Notice of Allowability

10/791,575

LIANG, GEORGE

EXAMINER'S AMENDMENT

FIG. 1

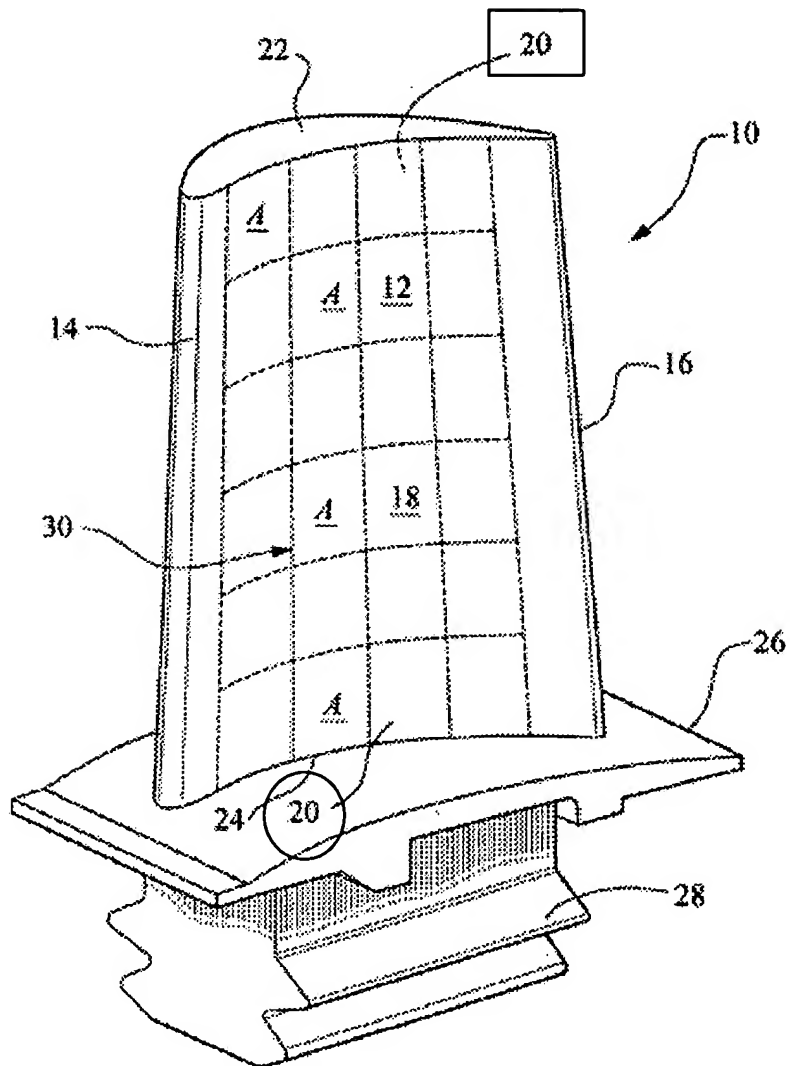
In Fig. 1 reproduced above, the numeral "20" shown in the box identifies the suction side, so the numeral "20" shown in the circle should be deleted.

FIG. 4A

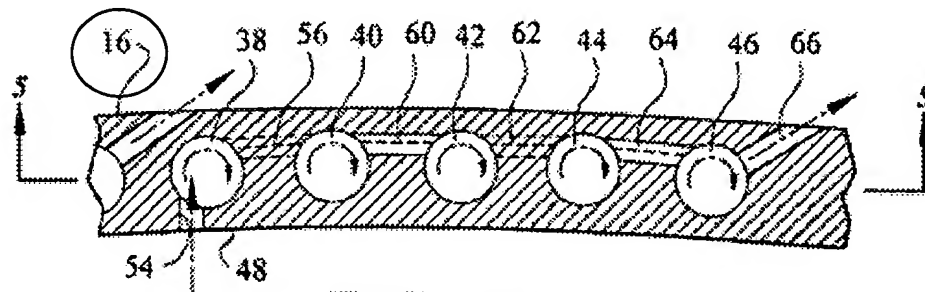
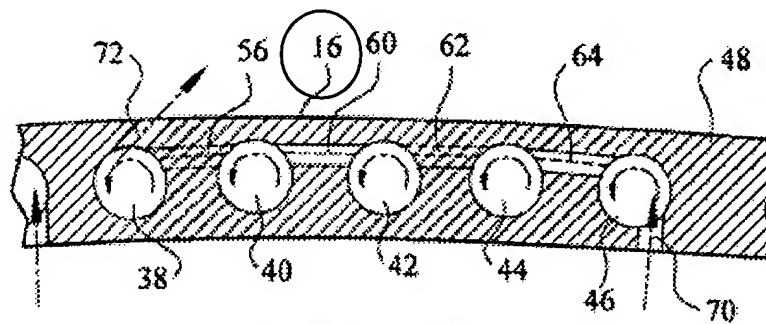
In Figs. 4A and 4B reproduced above, the numeral "16" (disclosed as a *trailing edge*) should be changed to "20" (disclosed as a *suction side*), commensurate with the disclosure.
